LONG BEACH CITY COLLEGE DISTRICT
CONTRACTS MANAGEMENT DEPARTMENT

BID C2194 BUILDING MM CONSTRUCTION TRADES 1 MODERNIZATION PROJECT AT THE PACIFIC COAST CAMPUS

ADDENDUM NO # 1

JULY 6, 2020

1 12KV SINGLE LINE DIAGRAM - RENO

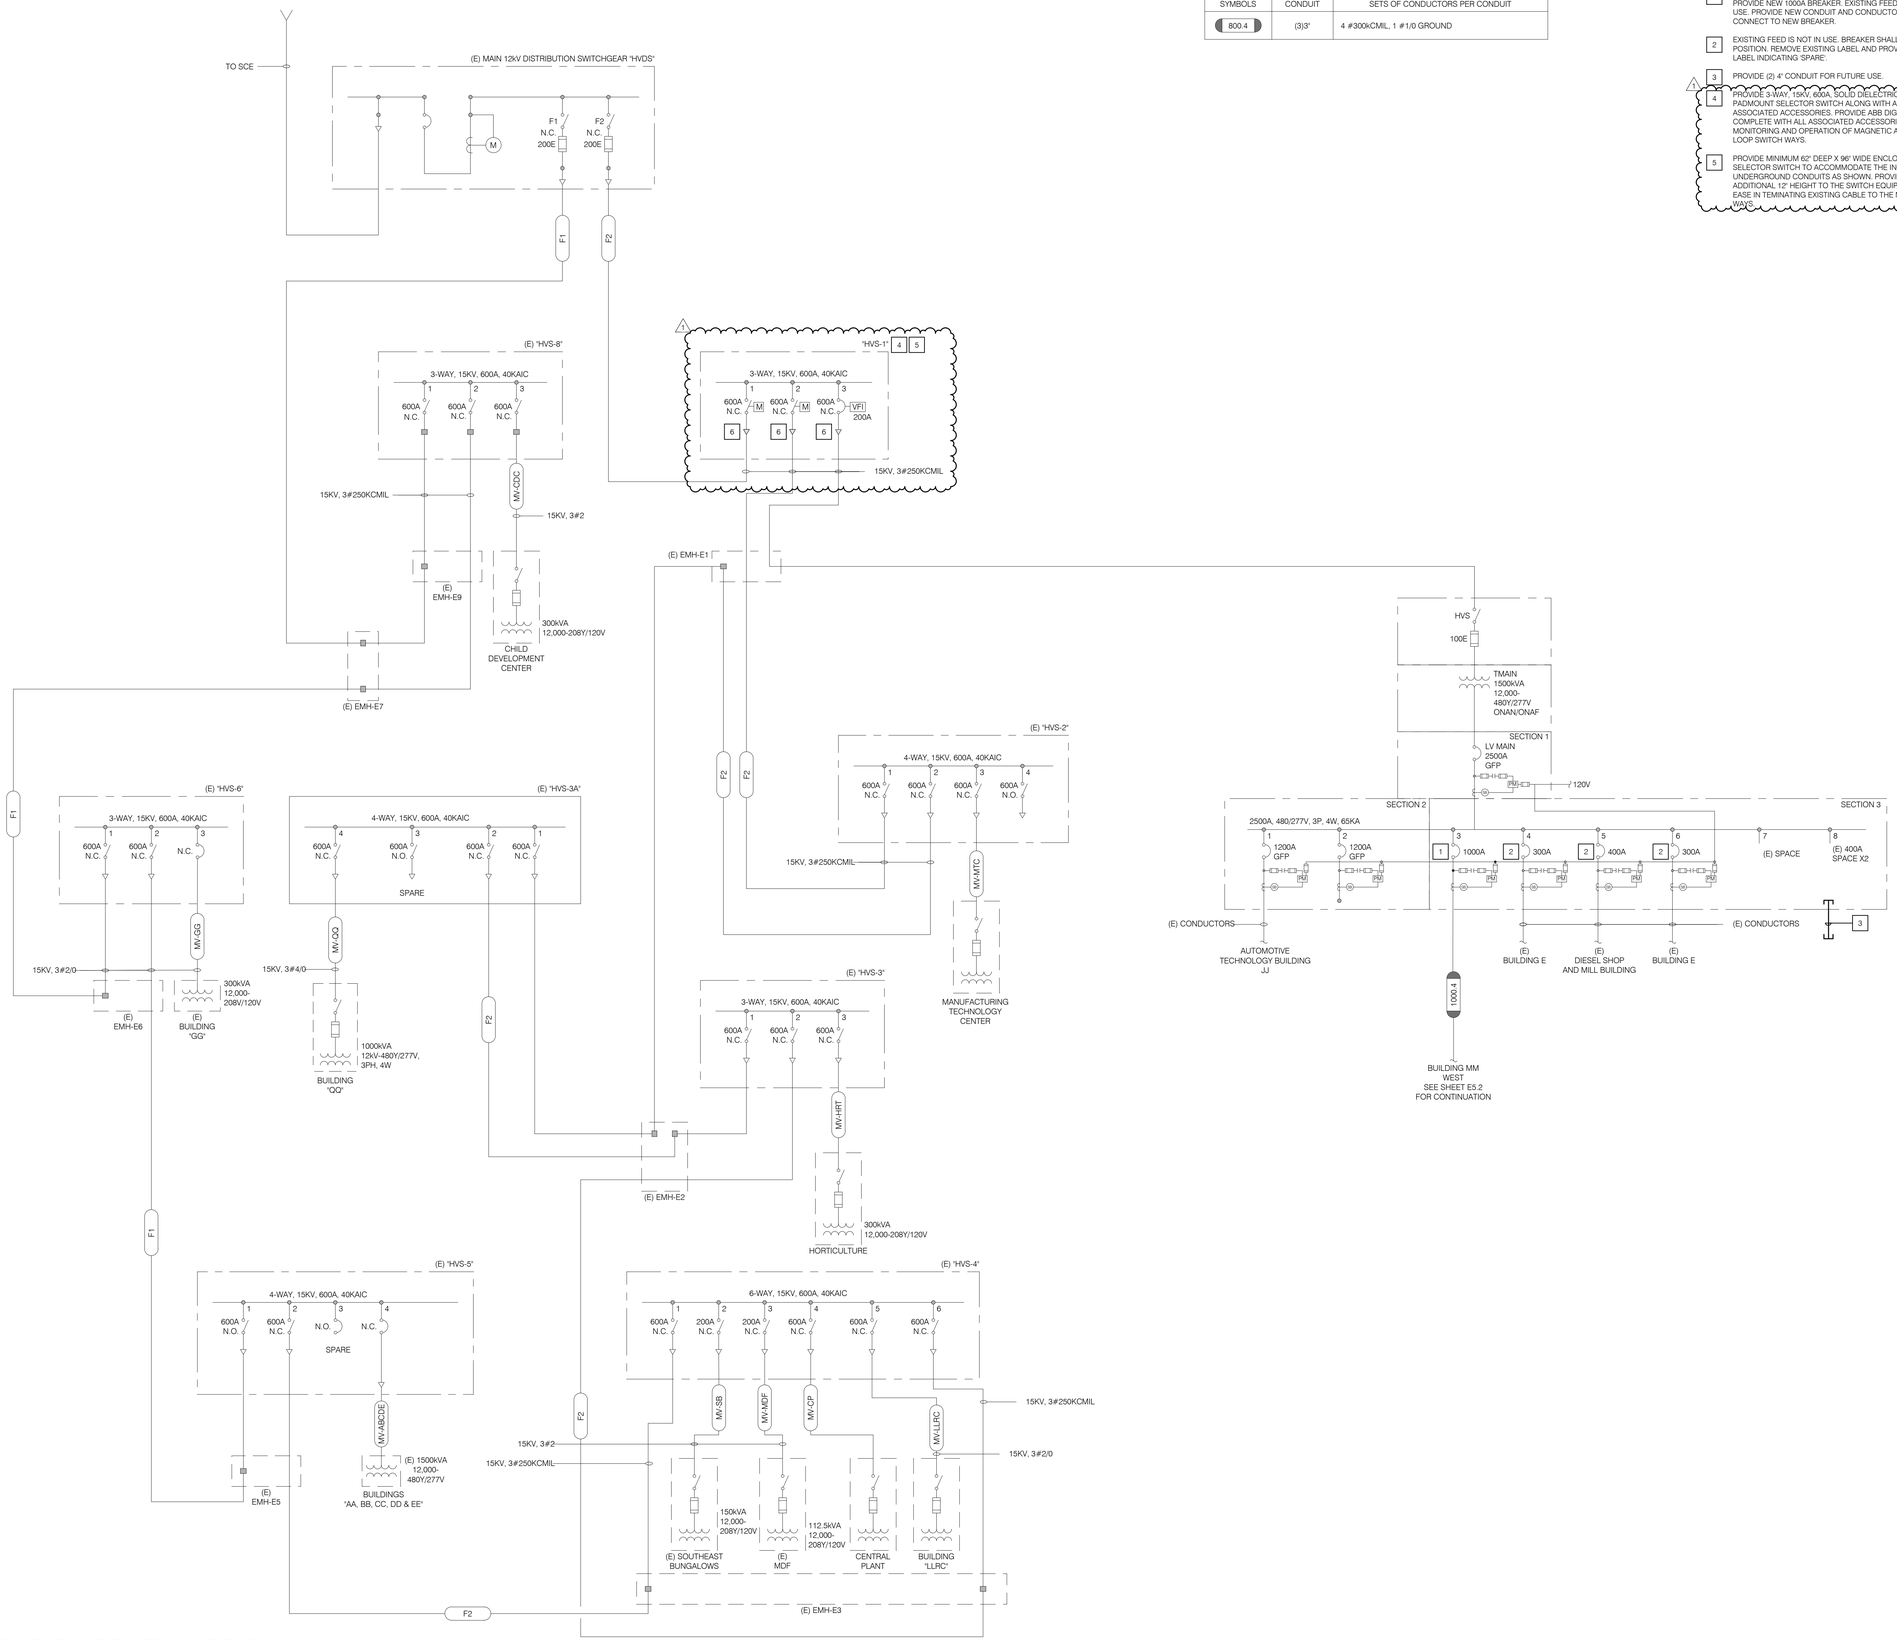
120.	Electrical	E5.11	Sheet added. MV reno single line added to include new selector switch.	Yes
121.	Electrical	E6.5	Panel mounting detail added for site temporary power panel 'TP'.	Yes
